Addendum 2
Solicitation 24-99375
Eng Svcs for Junction Avenue/St. Marie Street Reconditioning

This addendum serves to notify all bidders of the following changes to the solicitation documents:

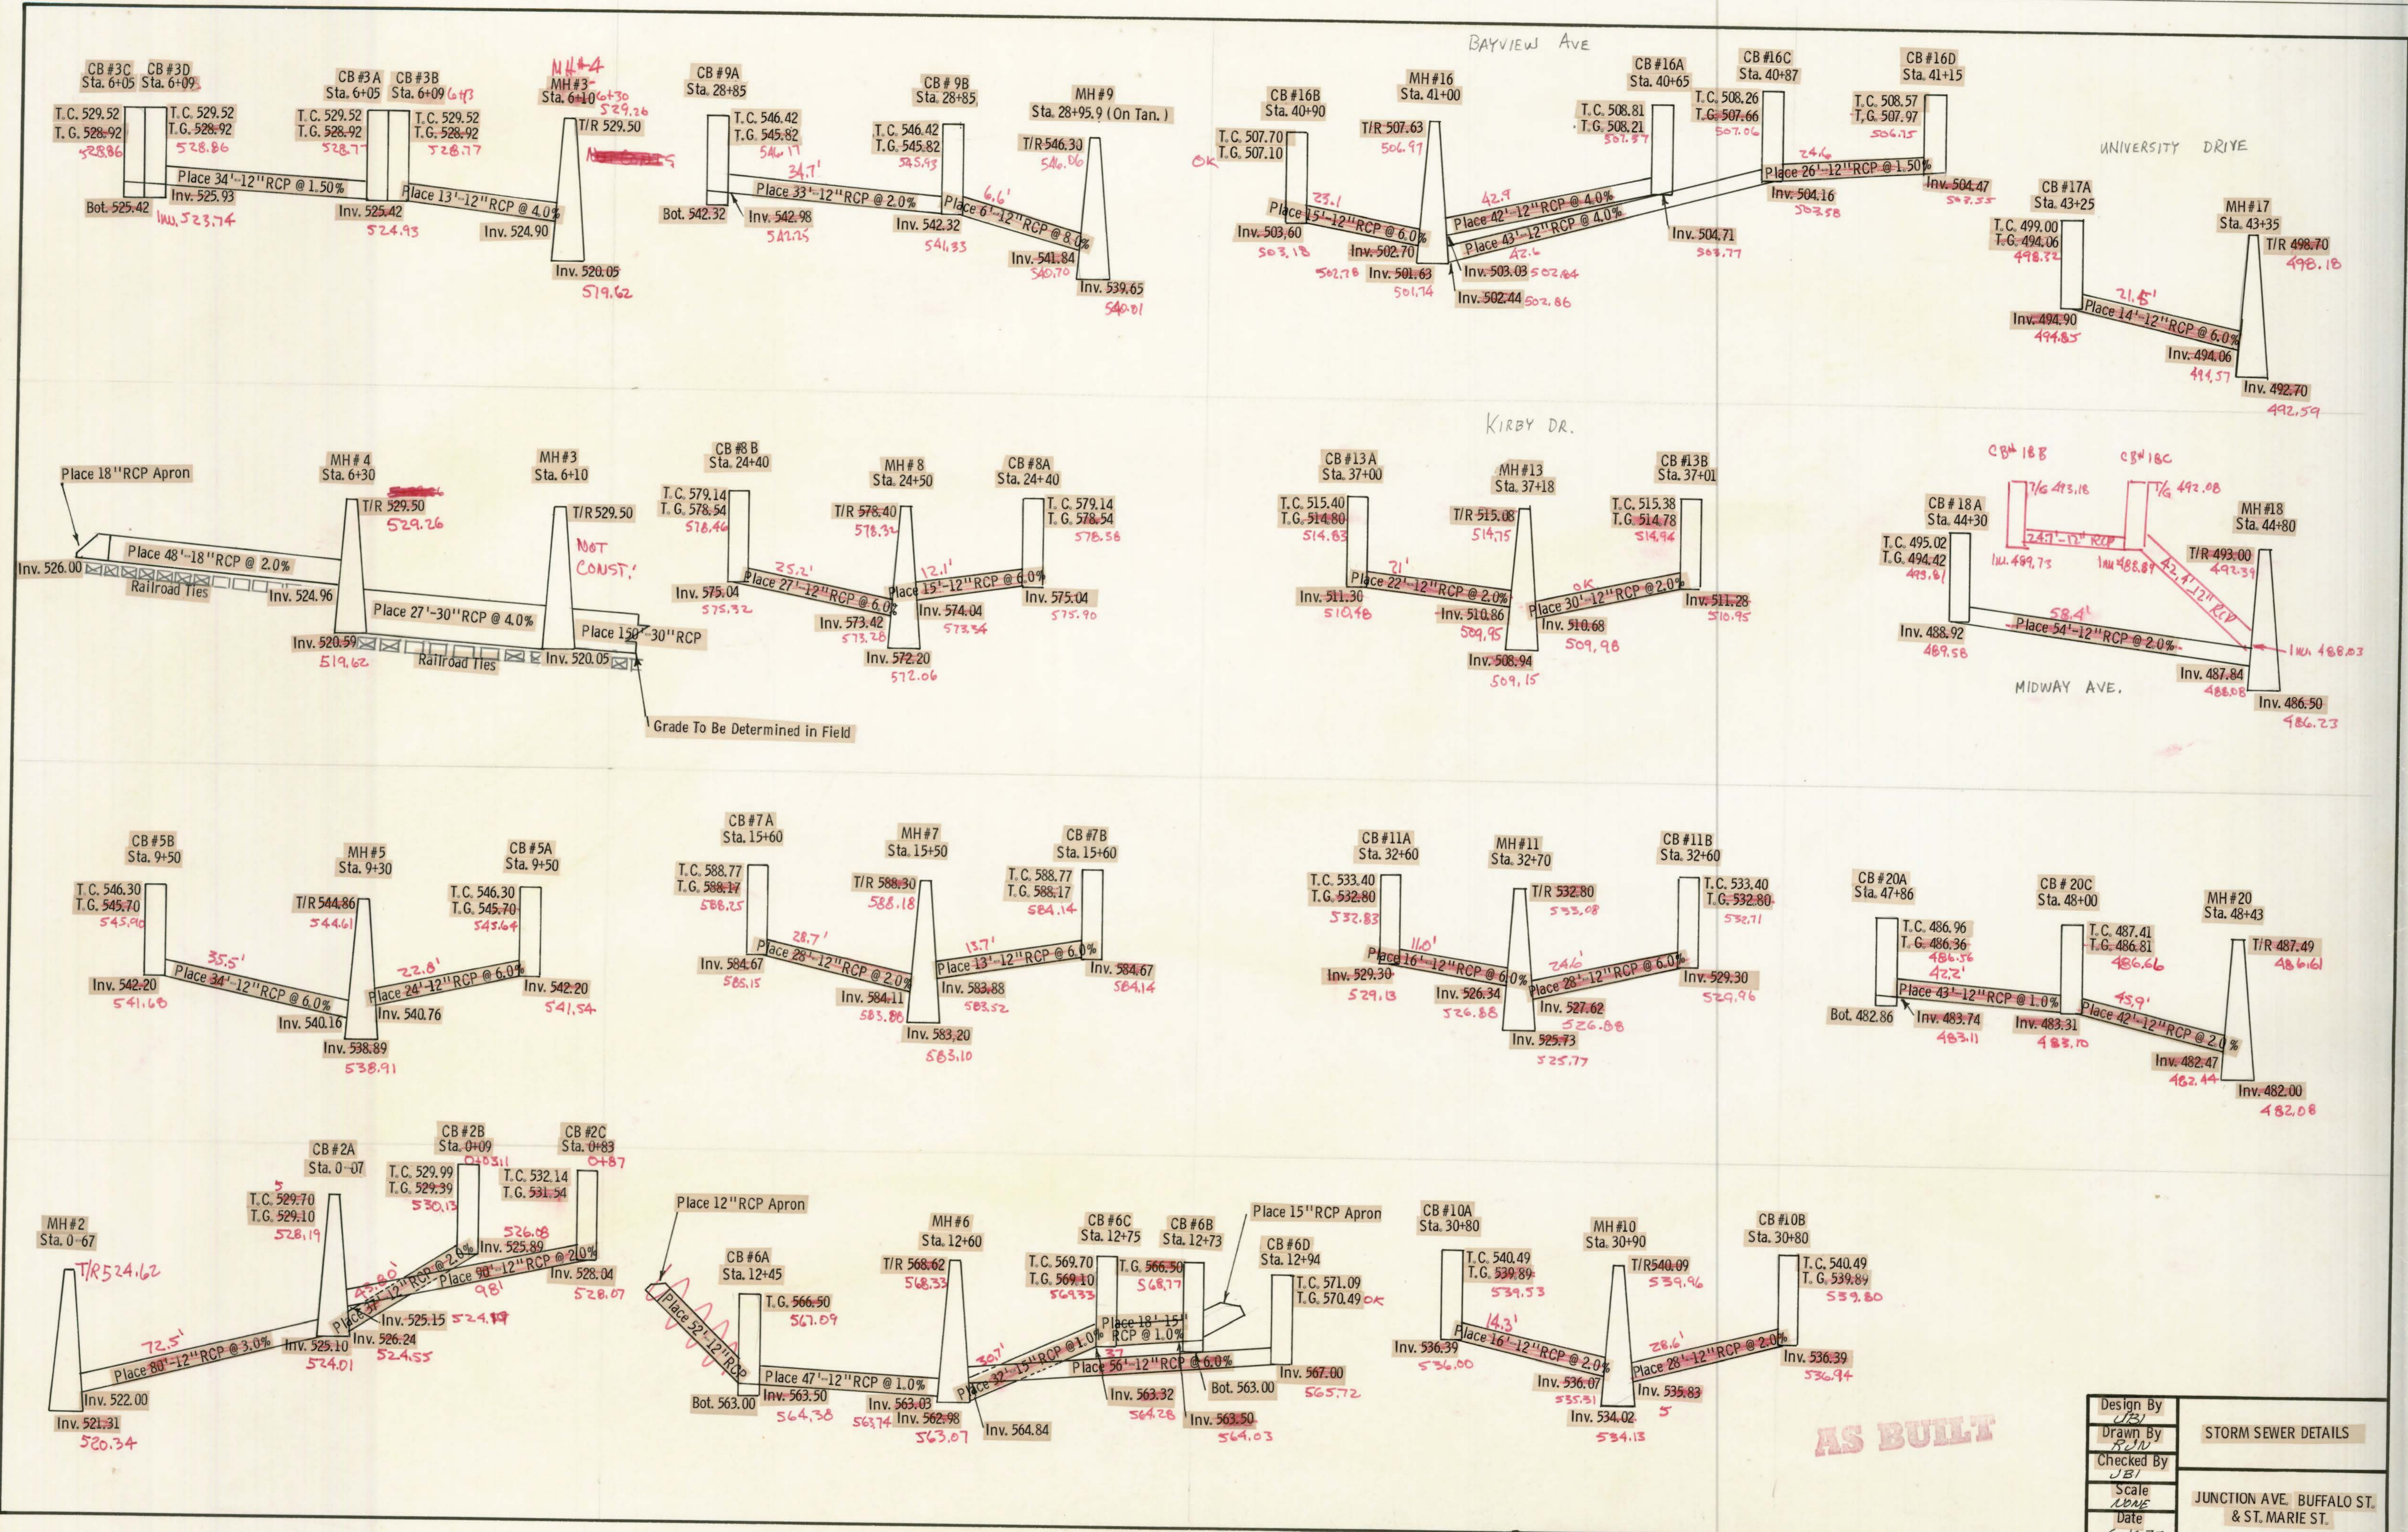
16. What will be determination for curb and gutter removal extents? Poor condition found throughout much of the project.

The site visit called for in the scope of services will be used to determine removal limits for the plans.
